North West Rail Link (NWRL)

Environmental Impact Statement 2

Group Response in regards to the use of Robert Road, Cherrybrook

The application number (SSI-5414)

An example of Current Traffic Movement along Robert Rd

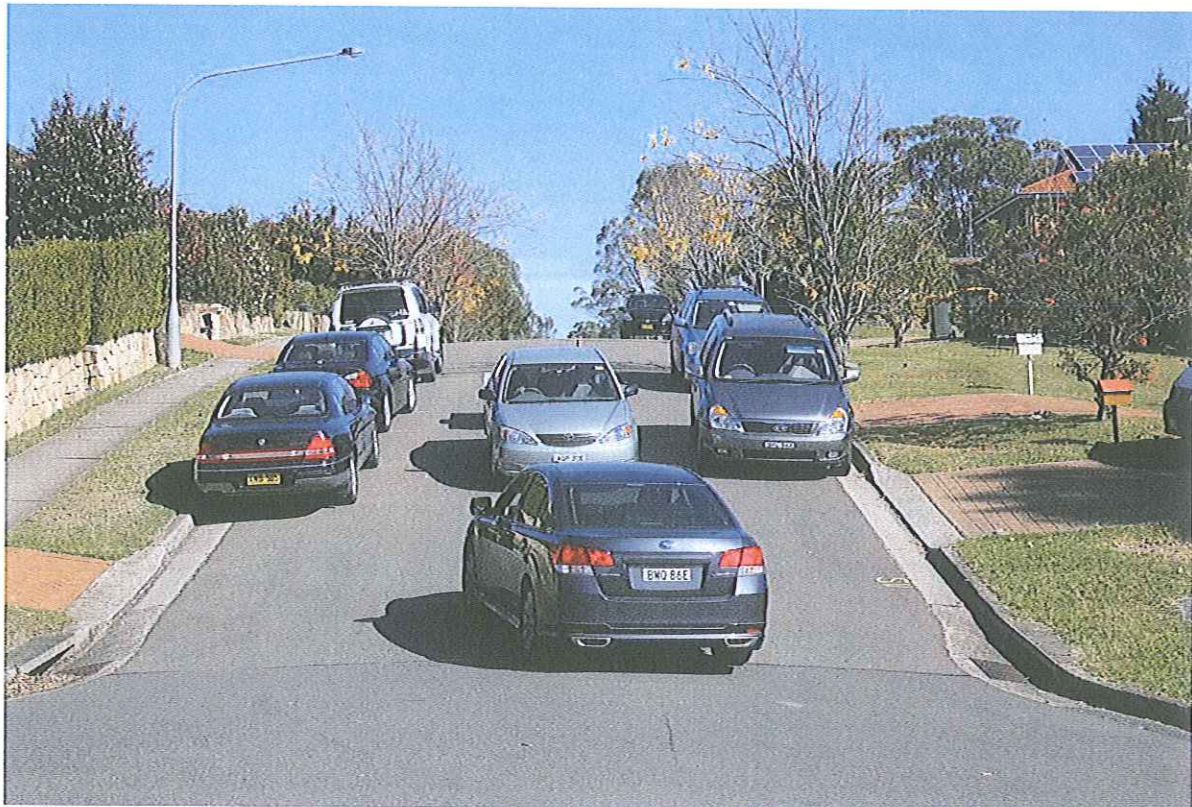
In its current form, Robert Road is currently designed to accommodate low level traffic for local residents. In fact it is so narrow at points, that when there is a car parked on one side of the road, only one car can pass through at a time. When there is a car parked on either side of the road at any point on Robert Road, one car must pull over to the side of the road to allow the oncoming car to pass.

Residents and users of Robert Road already appreciate the caution required when navigating through the road in its current state, including the need to regularly give way to oncoming traffic. In our view, any further traffic along this road will increase the likelihood of head on collisions. Further, the introduction of buses along any part of this Road in our view, will not only be impractical and more than likely not possible to achieve, it will almost certainly result in head on collisions. The pictures below provide an indication of the traffic congestion/movement already existing on Robert Road and the parking required for local residents and their visitors on a Saturday afternoon.

Entering and Exiting Robert Road from John Road

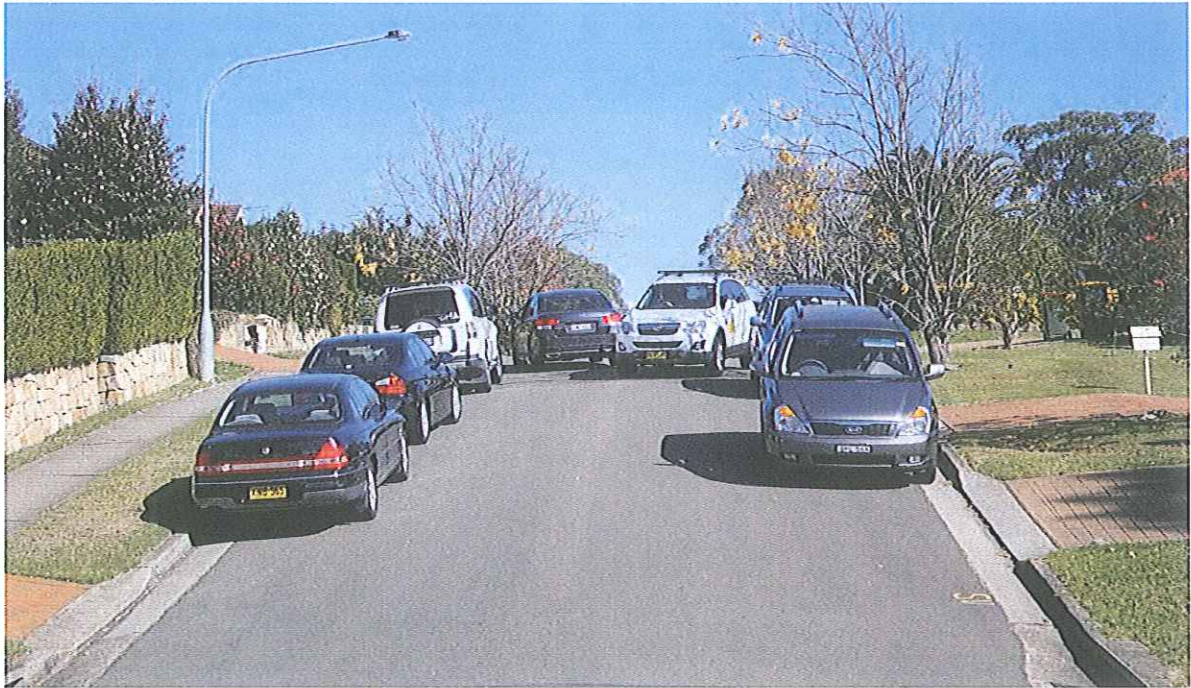
As traffic enters Robert Road from John Road, drivers travel up the crest of a steep hill which forms the beginning of Robert Road. This hill restricts the visibility for drivers to see oncoming cars travelling in the opposite direction down Robert Road towards John Road. Further, cars travelling down John Road turning left into Robert Road have absolutely no visibility until such time as they have turned into Robert Road, which gives them little time to adjust for oncoming cars coming over the crest of the hill.

Equally, the visibility of drivers travelling down Robert Road towards John Road, to see cars travelling up the hill on Robert Road (coming off John Road), is also poor.

To introduce any further traffic to this intersection in our view, will increase the likelihood of head on collisions. Further as mentioned in the section above headed "Current Traffic Movement along Robert Rd", the introduction of buses in this section in our view, will not only be impractical and more than likely not possible to achieve, it will almost certainly result in head on collisions. The pictures below demonstrate the existing traffic situation at the intersection of Robert Road and John Road.

Turning off John Rd either from the left or right into Robert Rd, vehicles meet with oncoming traffic coming over the crest of the hill, wishing to exit Robert Rd

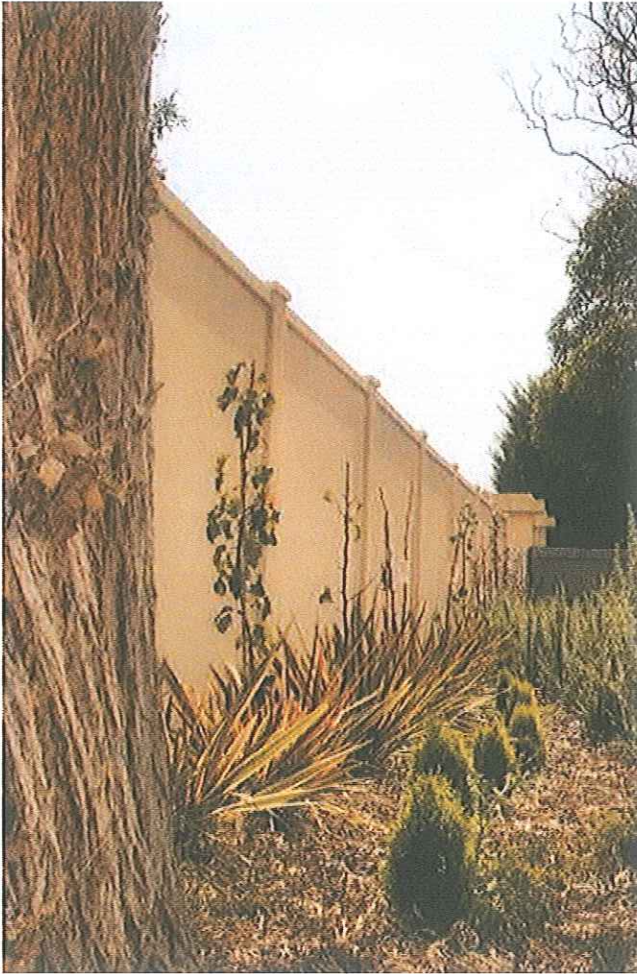
Environmental Impact Statement 2 provides a proposal as to the protection of the homes within Our Group against the Cherrybrook Station Precinct which will be located directly across the road from our homes. A diagram of this proposal is attached in Appendix B.

In a nut shell, the protection proposed in Appendix B is not only inadequate but with respect, in our opinion, provides a somewhat chaotic solution to those homes which will be most impacted by the Cherrybrook Station Precinct.

We would like to propose and are requesting that an alternate solution to that in Appendix B, be adopted. In particular, our alternate solution is attached in Appendix C and Appendix D.

Our alternate proposal in Appendix C simply involves:

1. Removing the NWRL proposed island of trees directly out the front of 1 Robert Road - as marked A on Appendix B.
2. Extend the proposed NWRL cul-de-sac road to allow vehicular access for the houses of 210 Castle Hill Road (also referred to as 1c Robert Road) and 1b, 1, 1a, 1/3, 2/3 and 3/3 Robert Road into and out of the cul-de-sac – as marked C on Appendix C.

3. Create a vehicle entry/exit point into/out of the cul-de-sac road as far north east of 1/3 Robert Road as possible – as marked D on Appendix C.
4. Create a continuous shield/buffer zone of high density trees to the maximum depth possible, east of the cul-de-sac road, in order to provide the residents at 210 Castle Hill Road and 1b, 1, 1a, 1/3, 2/3 and 3/3 the maximum protection from visual and acoustic disturbance possible – as marked B on Appendix C. We propose that the height and density of the trees selected to with the aim of providing the highest level of acoustic and visual protection possible. In addition, to provide further acoustic protection, we have proposed in point 7 below, acoustic walls to be situated on the eastern side of the trees.

5. Move the portion of Robert Road which has been proposed by NWRL as the entry point into the Cherrybrook Station spine road, as far east as possible – as marked A on Appendix C.

6. Create a shield of high density trees out the front of 1/3 and 5 Robert Road to the maximum depth to allow as much protection from visual and acoustic disturbance to these houses as possible - as marked E on Appendix C.

7. Create residential acoustic wall on the eastern side of the continuous shield of trees – as marked F on Appendix C. Some examples of residential acoustic walls are attached in Appendix E.

APPENDIX H

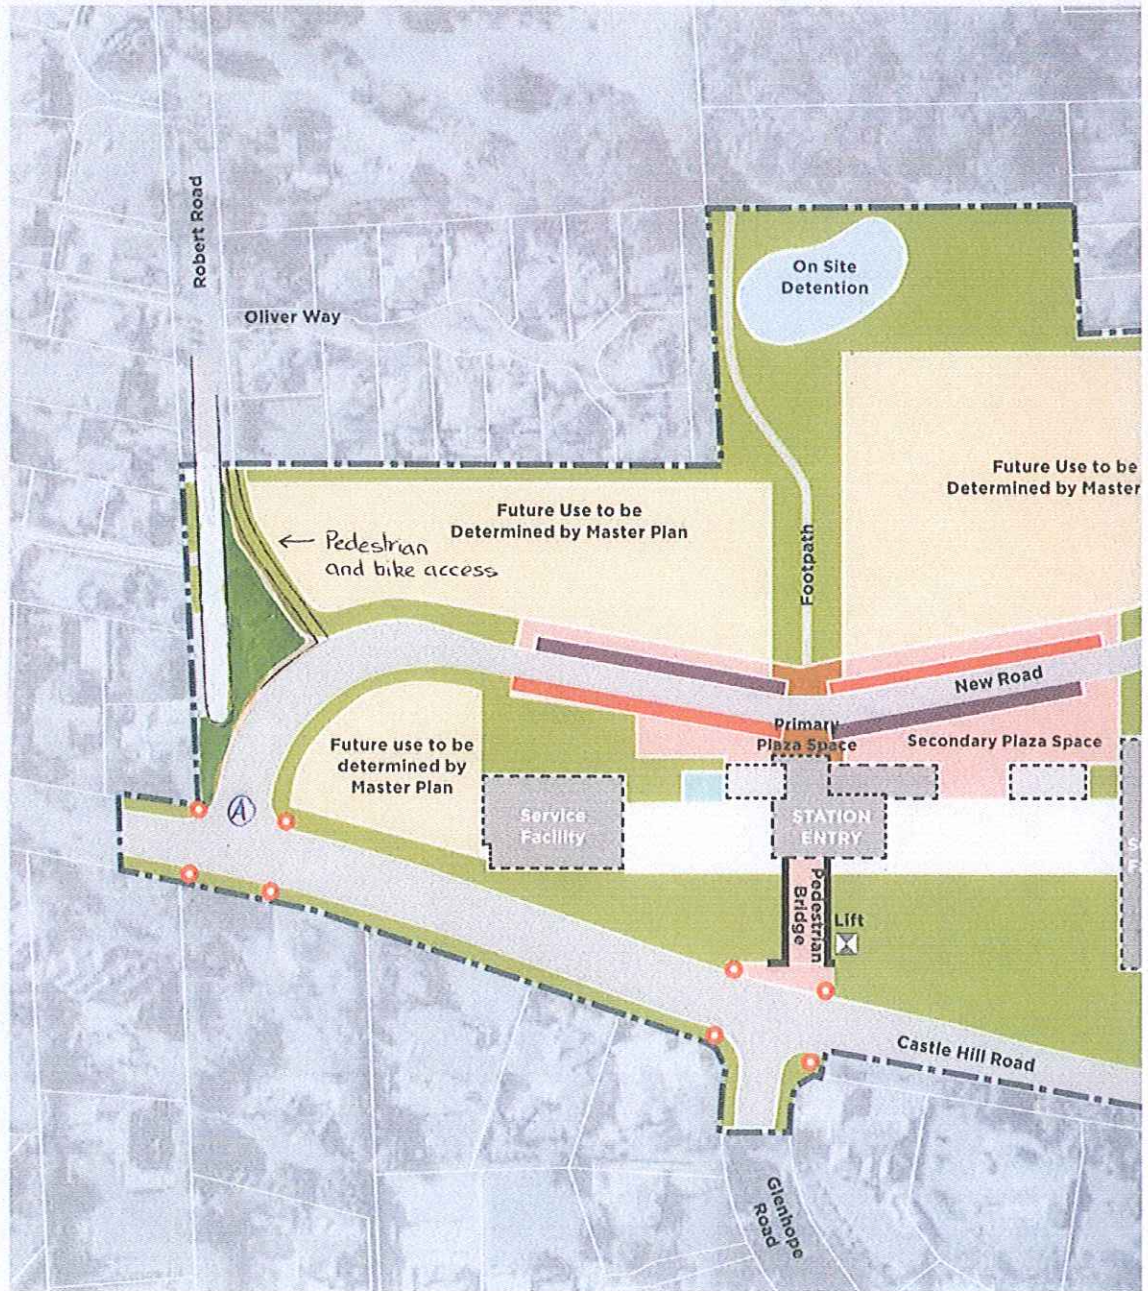
All residents occupying the section east of Franklin Road have no option but to pass through Franklin Road or Castle Hill Road in order to access the Cherrybrook Station Precinct, whether travelling by public transport or otherwise. Therefore, naturally, access to the station would be via one of these roads. Where access is gained from Castle Hill Road, we propose that transport would enter the station at the proposed Robert Road traffic lights as marked A on Appendix H.

Rather, we propose a low impact/low cost option. That is, all transport would continue to flow through County Drive and left onto Castle Hill Road to then access the station at the proposed Robert Road traffic lights as marked A on Appendix H. In this way, County Drive would continue to be utilised for the purpose it was intended as more fully described by the then Castle Hill MP,

Proposals Regarding Closure of Robert Road to avoid vehicular access heading south up Robert Road into the Cherrybrook Station – See Appendix H

We propose that Robert Rd be converted into a cul-de-sac (as shown in Appendix H) based on the following:

- 1. As detailed above, we believe there is no requirement to use Robert Road heading south as an access point into the Cherrybrook Station Precinct.
- 2. The creation of a cul-de-sac would avoid the build up of traffic and potential accidents in a local street that has not been built to be utilised as a main road.
- 3. Residents of Robert Road:
 - a. bought into Robert Road on the basis that the road would continue to be a low traffic street with close proximity to the upcoming Franklin Road Railway Station. Consequently, they have paid market value based on these factors; and
 - b. have made decisions not to sell their property in Robert Road on the basis that the road would be a low traffic street with close proximity to the upcoming Franklin Road Railway Station.
